PLANNING AND ZONING BOARD STAFF REPORT

Delray Business Incubator

Meeting	File No.	Application Type
January 27, 2024	2023-159-SPF-SPR-LV4	Level 4 Site Plan with 1 variance & 3 waivers
Property Owner	Authorized Agent	
GS Deerfield LLC	John Tice

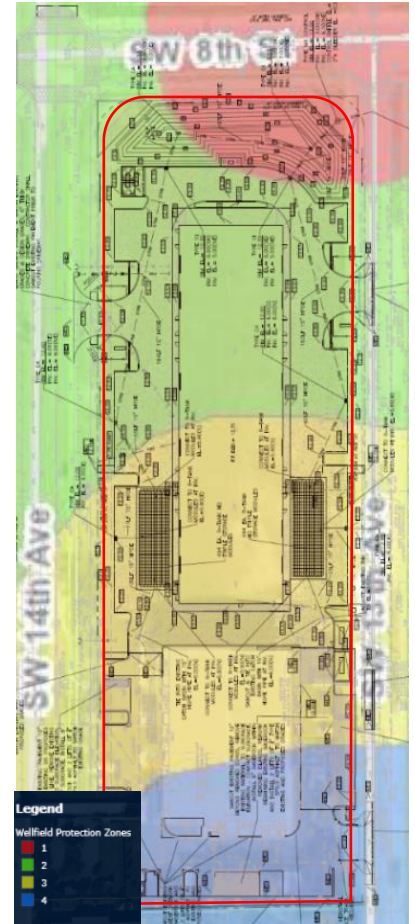
The existing well (12-17E) is located across from the subject property on SW 8th Street within Zone 1 (red). Although a portion of the subject property is located within Zone 1, the building footprint is confined to Wellfield Zone 2 (green) and Zone 3 (yellow). According to Palm Beach County Environmental Resources Management, new exfiltration systems are prohibited within Zones 1 and 2. Any future businesses that occupy the proposed warehouse, particularly those storing regulated substances, shall apply for a Wellfield Protection Operating Permit with the Palm Beach County Department of Environmental Resources Management to confirm that the use meets the requirements of the Wellfield Protection Ordinance.

The proposed exfiltration system is designed within Zone 3 (yellow), with all the catch basins and manholes located on the north side of the subject property. These will be constructed using precast concrete and are designed to prevent percolation into the groundwater. The applicant has submitted the required affidavit of notification to the Palm Beach County Environmental Resources Management, ensuring compliance with wellfield protection regulations. for further details, see the attached correspondence.

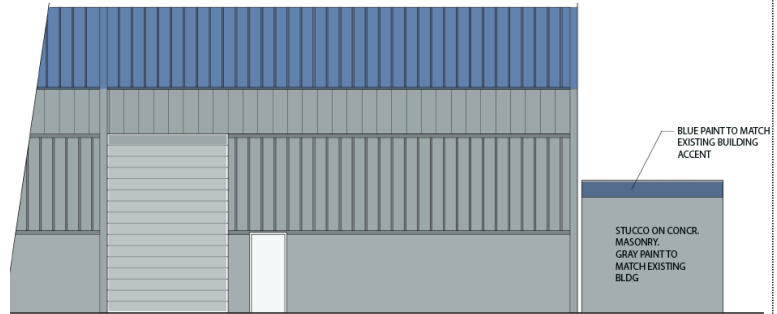
The proposed generator is located between the two buildings, north of the existing building. The generator is confined by concrete enclosure and landscape compatible with the existing Rapid Response building color (image at right).

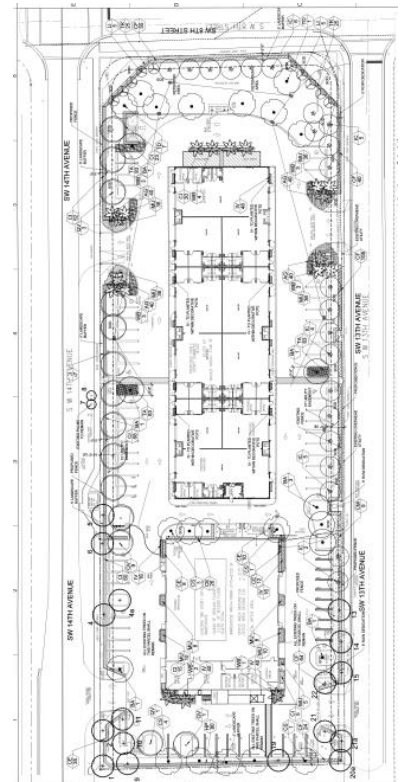
The landscaping plan for the proposed development has been evaluated for consistency with LDR Section 4.6.16. The project incorporates a lush and substantial landscape design along the perimeter of the site (image at right, and attached as full size).

At the front of the lot along SW 8th Street, a retention area is proposed, enhanced with Dahoon Holly Trees, hedges and sod, contributing to a functional and aesthetically pleasing frontage. Along the west perimeter, the design includes a 12-foot, 6 inches landscape buffer, lined with Live Oaks, hedges and sod, creating a substantial green edge.

Due to the 5-foot right-of-way (ROW) dedication along SW 13th Avenue, the previously existing 5-foot landscape buffer between the parking area and the right-of-way on the east side of the site has been eliminated, resulting in non-conformity. To address this, the applicant has included a request for a landscape waiver to reduce the buffer requirement to zero feet for the existing parking spaces along the east side (discussed in detail below). The eastern property line is not un-landscaped, however. There is a 7-foot, 7-inch-wide landscape buffer provided up to the existing parking spaces on the east perimeter, featuring Dahoon Holly Trees, hedges, and sod, to maintain continuity and greenery.

Despite the non-conformity created by the ROW dedication, the overall landscape plan has been reviewed and deemed technically compliant by the Senior Landscape Planner, except for the requested waiver. The proposed plan effectively integrates lush and functional landscaping across the site, enhancing its appearance while meeting the general intent of the LDR Section 4.6.16 regulations.

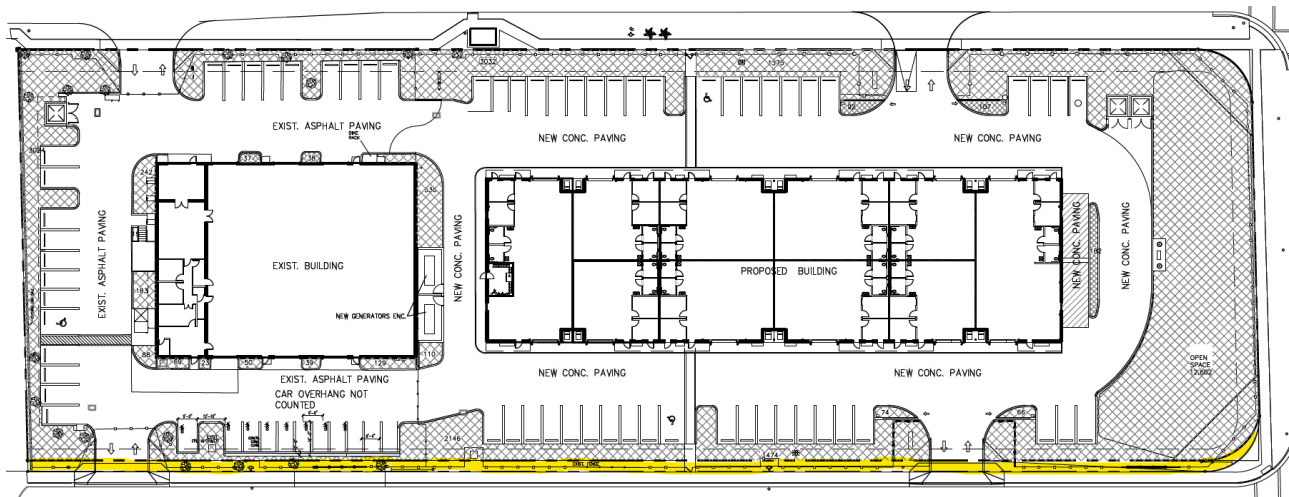
Following a required **5-foot right-of-way dedication** (image below), the total site area is reduced to **108,008 square feet**. The resulting open space provided is **25,822 square feet**, which does not meet the 27,002 square feet required by the regulation. The variance request seeks relief to reduce the open space requirement to **23.9 percent**, based on the proposed site design and its constraints.

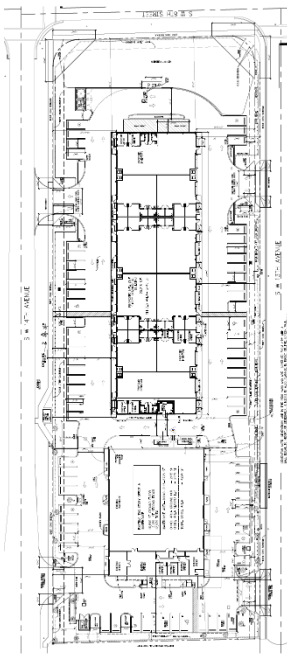
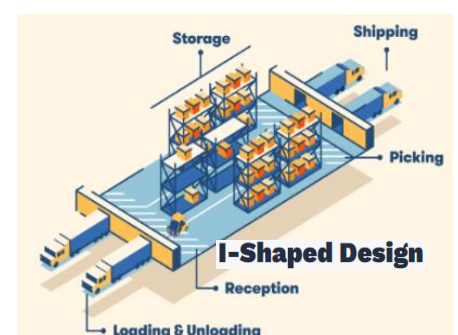
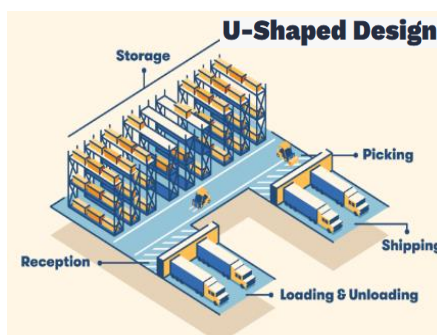
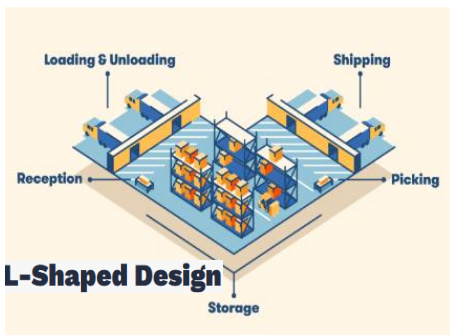
There are three common warehouse layouts, which are selected based on the unique needs of the user; U shaped, L shaped, and I shaped (images below). Typically, these warehouse layouts are for large single-tenant importers, exporters, manufacturers, and wholesalers frequently positioned in industrial parks or on the outskirts of towns or ports to allow convenient access to roads and loading docks.

The proposed development is in an “I” shape layout with 10 tenant bays with 12 total overhead doors (image at left). This style is similar to the surrounding buildings west of the property for warehouse businesses with the typical “I” shaped layout with multiple overhead doors facing the right-of-way.

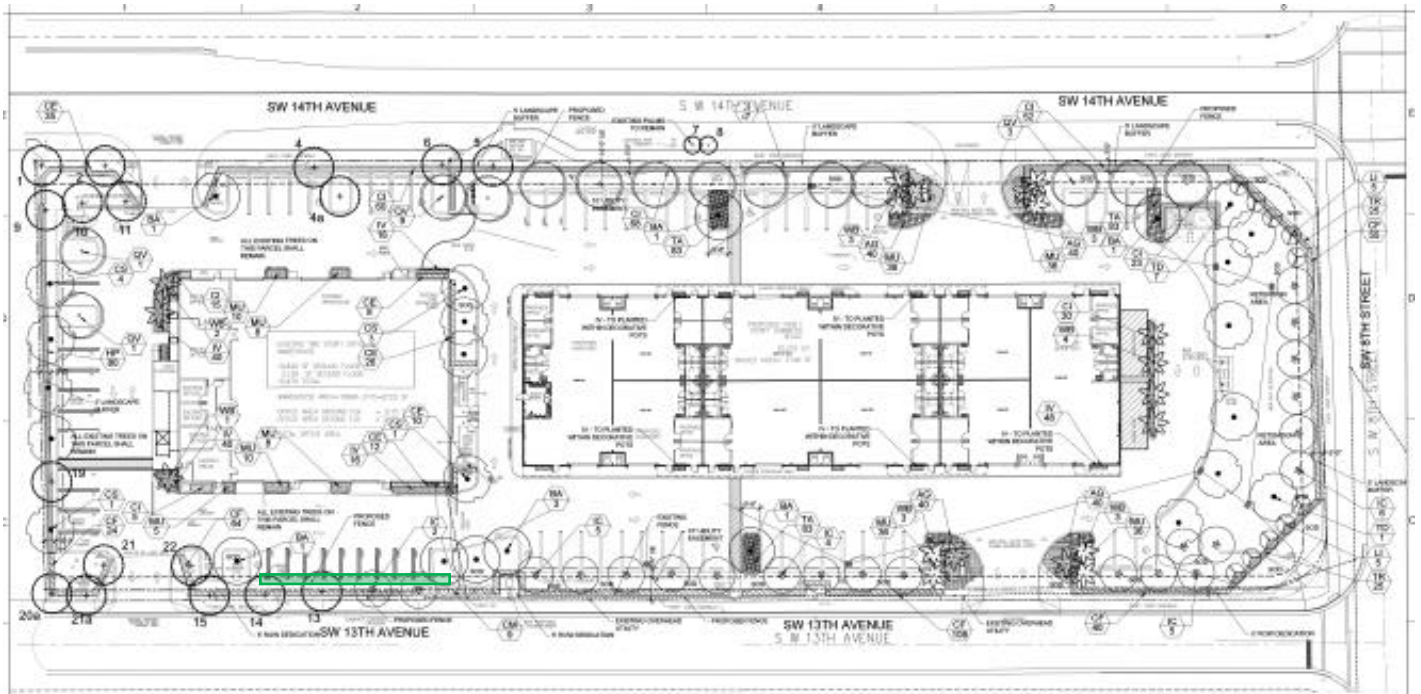
The existing 12,979 square foot, 2-story warehouse structure located at the southern portion of the parcel has existing parking spaces along SW 13th Avenue, with the required 5-foot landscape buffer. With the required 5 feet right-of-way dedication along SW 13th Avenue, the existing 5-foot landscape buffer will be reduced to 1-foot, creating a non-conformity to the parking lot design.

The applicant has requested a reduction to the required landscape buffer only along the 11 existing parking spaces on SW 13th Avenue while providing the prerequisite of a minimum 5-foot landscape buffer for the new development. The image below indicates the location of the requested waiver.
